Access Compliance Report

Public Rights-of-Way

Intersection ID: 46481	Main Street: REVENNA_LN	Cross Street: BERKELEY_PLACE_DR	Location: W
ADA ID: 59BE1C1BF4B0	Ramp Type: PerpDiag	Initial Pass/Fail: Fail	Overall Compliance: No
Severity Score: 13.75			
Codes/Mitigation Info/Possible Solution		Field Measurements/Component Compliance

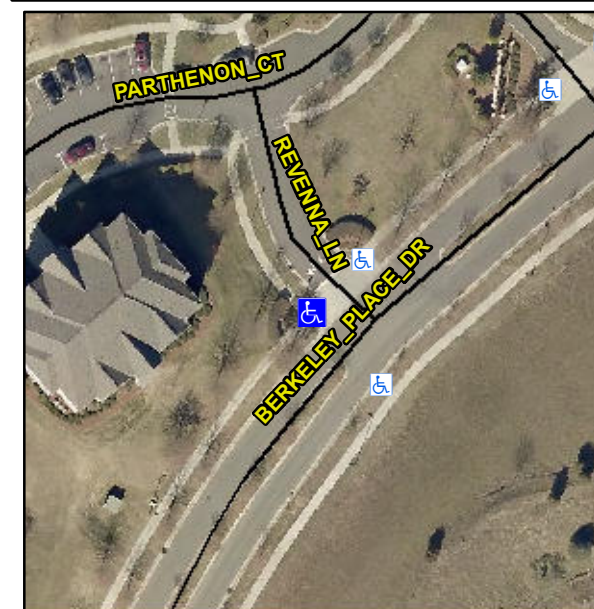
Remove & Replace Curb Ramp With Two New Directional Ramps or Equivalent.

R304.2.2, R304.5.3
